To: T10 Technical Committee
 From: Rob Elliott, HP (elliott@hp.com)
 Date: 2 November 2005
 Subject: 05-381r0 SAS-2 Multiplexing

sas2r00 - Serial Attached SCSI - 2 revision 00

Overview

Figure 3 — Phy class diagram

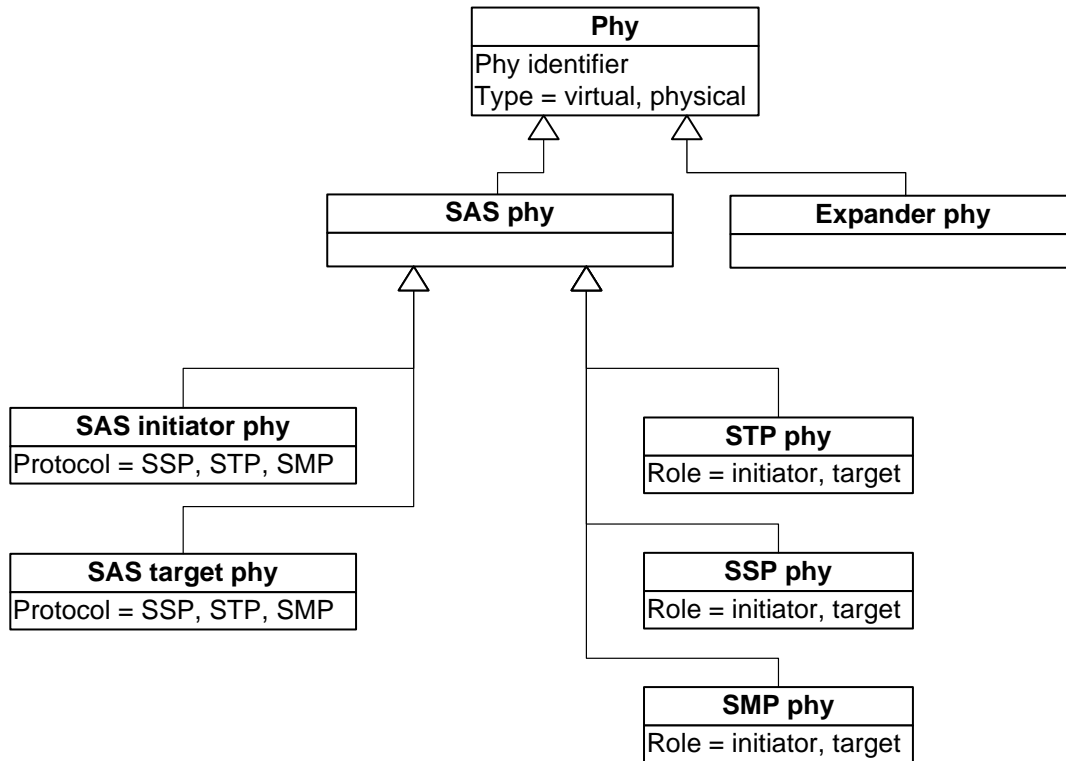
Editor's Note 1: Logical phys need to be included in the UML model, perhaps just as another attribute or a new value in the Type attribute.

Figure 13 — Reset terminology [\[updated to add multiplexing sequence\]](#)

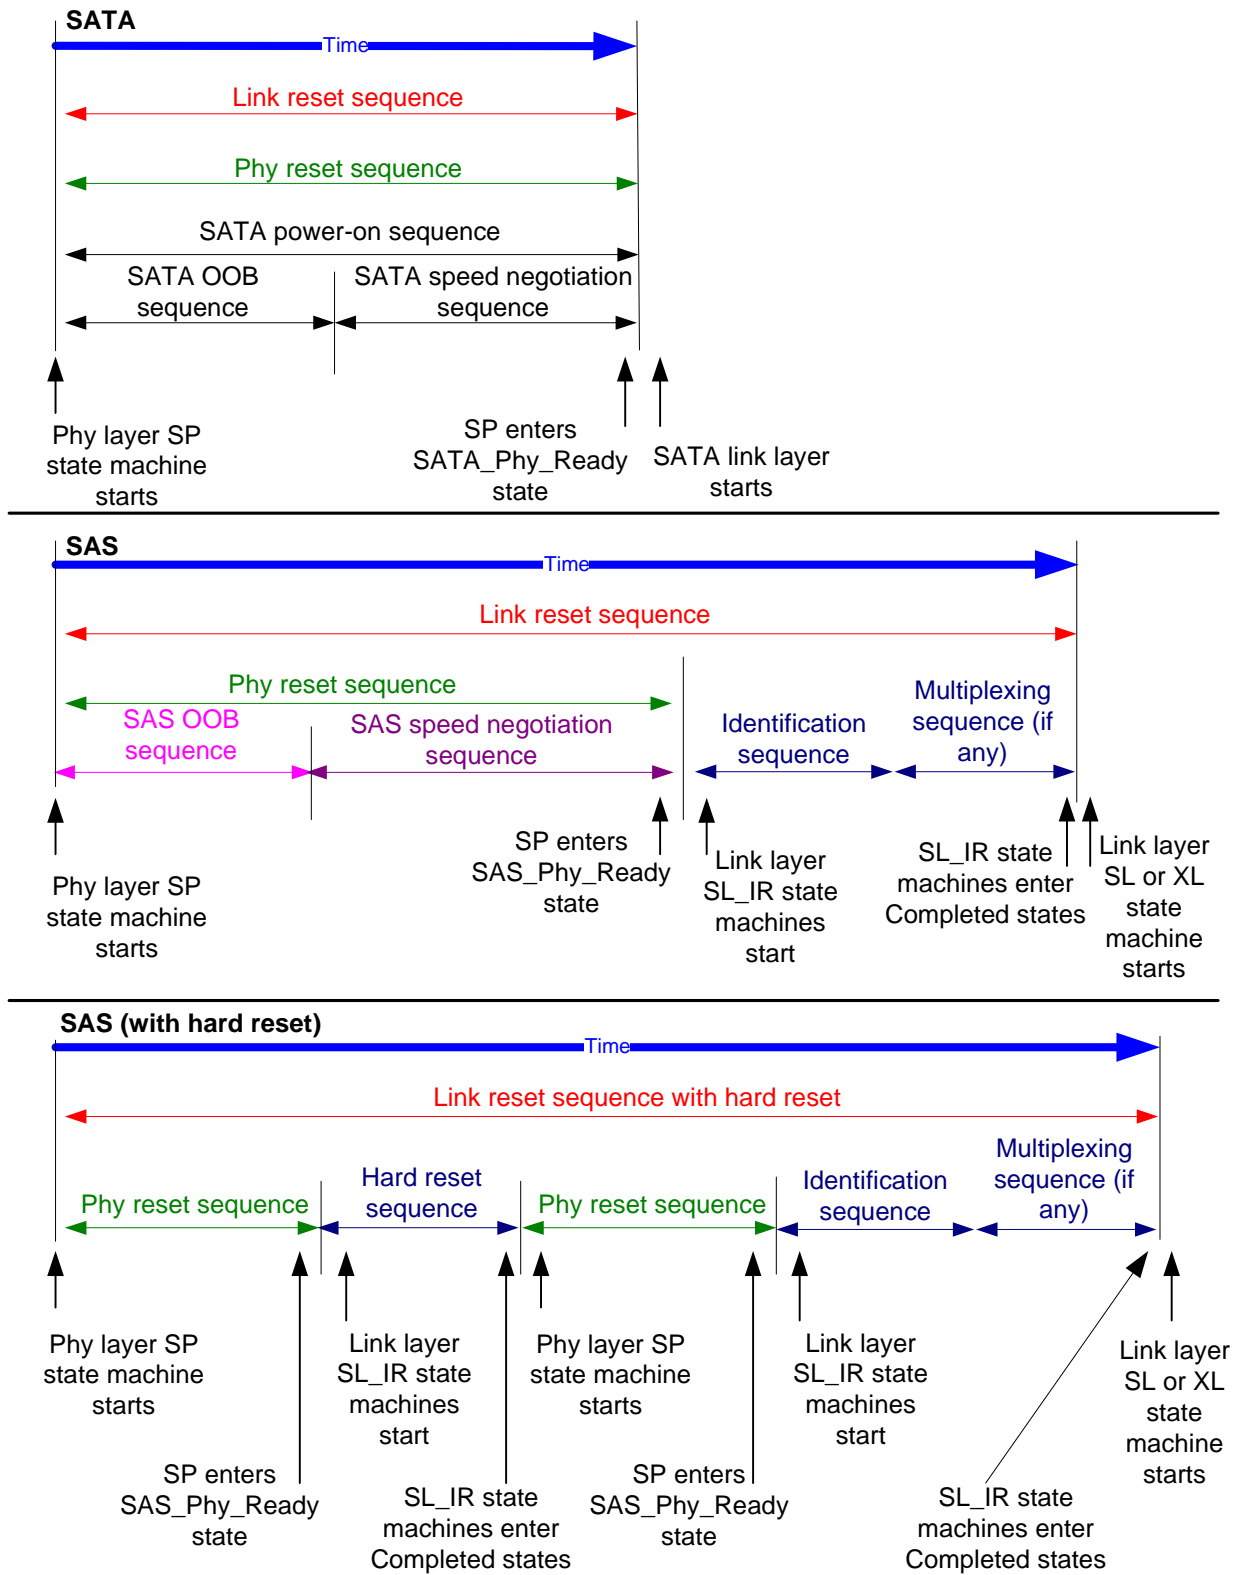
- a) link reset sequence;
- b) phy reset sequence (see 6.7);
- c) SATA OOB sequence (see 6.7.2.1);
- d) SATA speed negotiation sequence (see 6.7.2.2);
- e) SAS OOB sequence (see 6.7.4.1);
- f) SAS speed negotiation sequence (see 6.7.4.2);
- g) hard reset sequence (see 7.9);
- h) identification sequence (see 7.9); [and](#)
- i) [multiplexing sequence \(see 7.x\).](#)

Figure 14 — Multiplexing bandwidth allocation

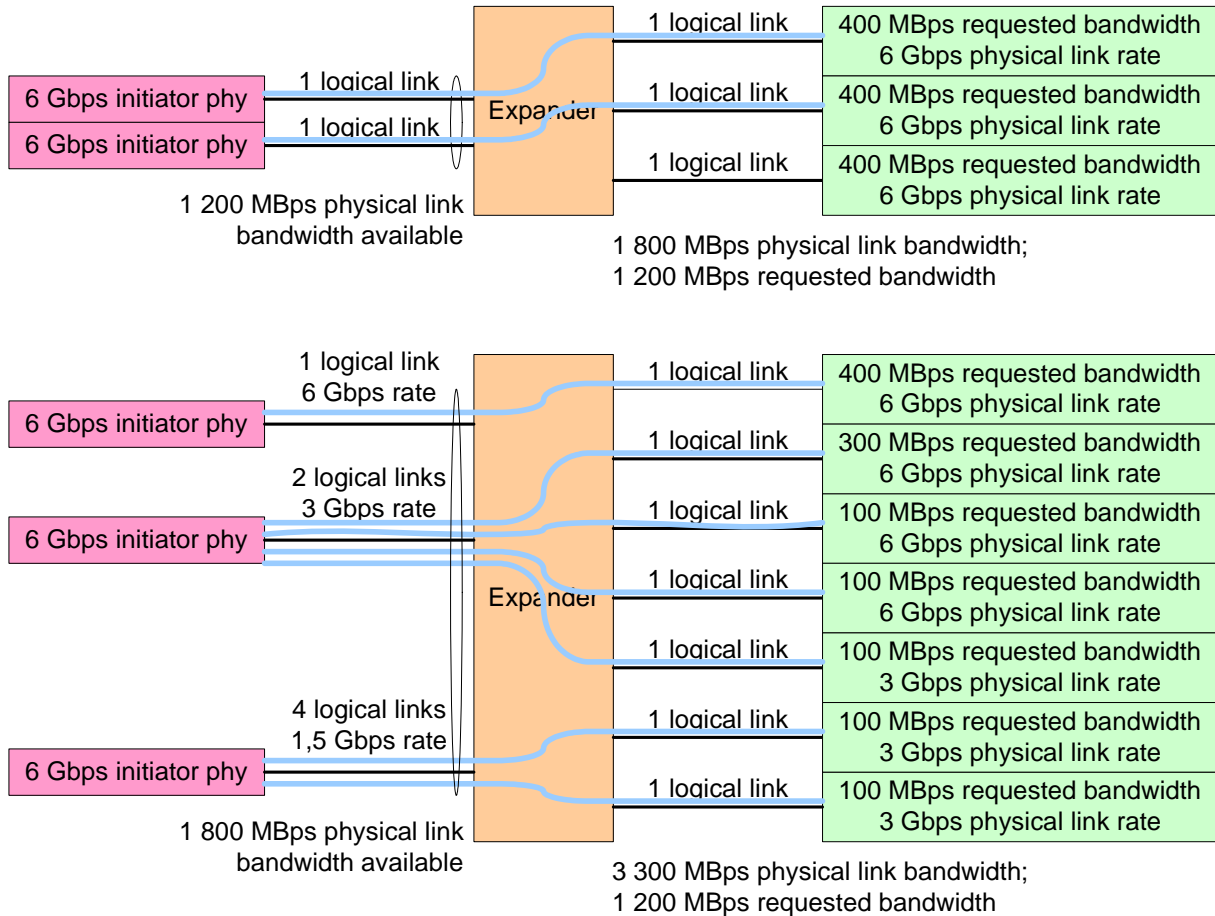
If the SAS domain contains a mixture of target phys with different physical link rates, then the management application client should multiplex physical links between initiator phys and target phys that request specific bandwidth in the REQUESTED BANDWIDTH field in the IDENTIFY address frame into logical links supporting connection rates supporting the lower of the requested bandwidth and the maximum connection rate of the pathway to the target phy.

- 1) 6 Gbps allocations:
 - 1) Multiplex 6 Gbps physical links into 6 Gbps logical links (i.e., no multiplexing) and mark the logical links available;
 - 2) Allocate 6 Gbps logical links to target phys requesting 300 MBps or greater bandwidth;

- 3) Allocate any unused bandwidth in the 6 Gbps logical links to target phys requesting that bandwidth;
- 2) 3 Gbps allocations:
 - 1) Multiplex any unallocated 6 Gbps physical links into 3 Gbps logical links; [favor 1:2 over 1:4]

Figure 16 — Multiplexing

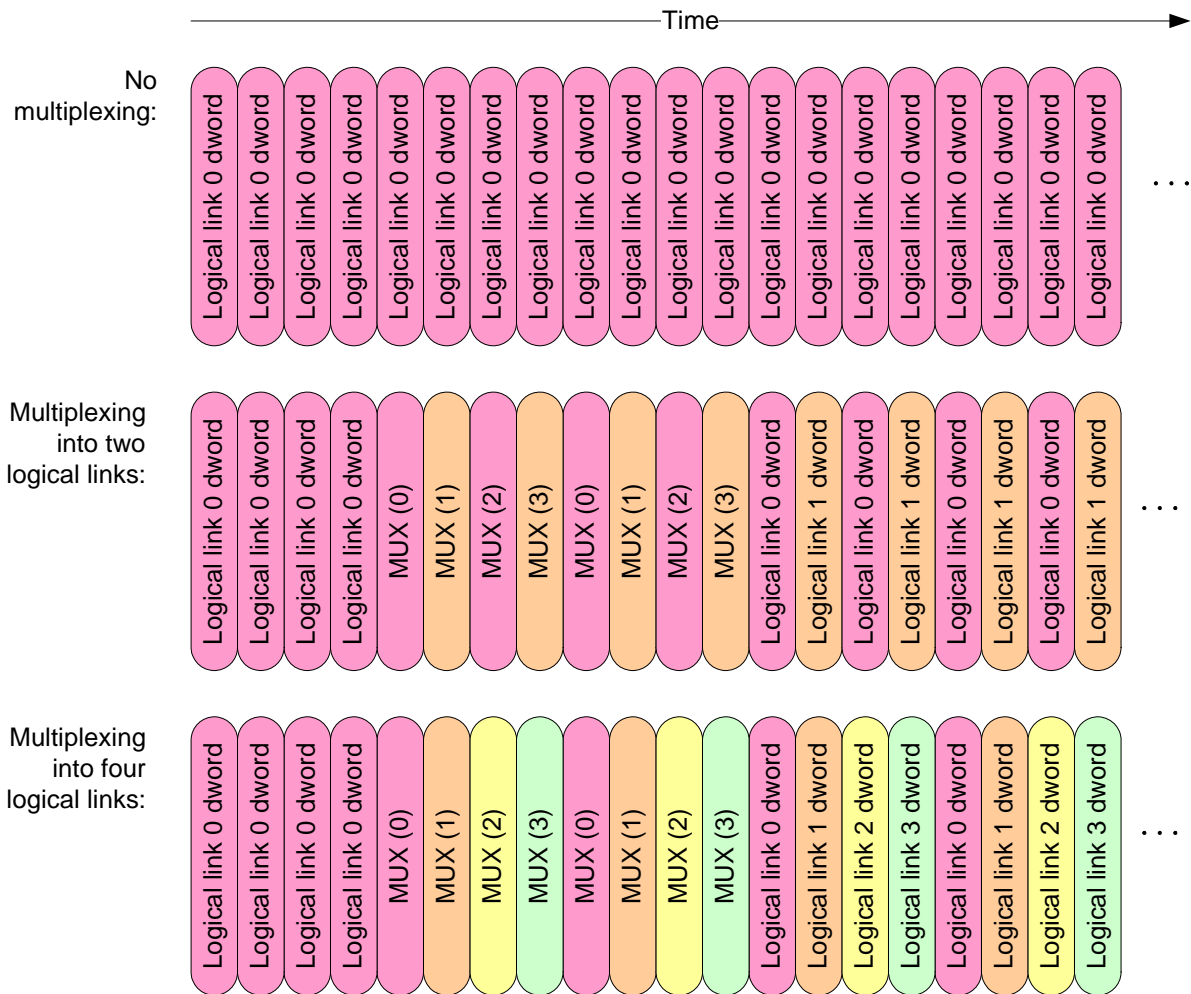
The phy shall transmit MUX repeatedly, rotating through MUX (0), MUX (1), MUX (2), and MUX (3) in order. The phy shall not transmit ALIGNs and/or NOTIFYs during the multiplexing sequence.

After the phy receives at least 3 MUX primitives confirming the position of dwords in each logical link, it shall continue transmitting at least 24 MUX primitives. The phy shall then stop transmitting MUX and the logical phys shall start transmitting dwords for the logical links in the corresponding positions as shown in figure 16.
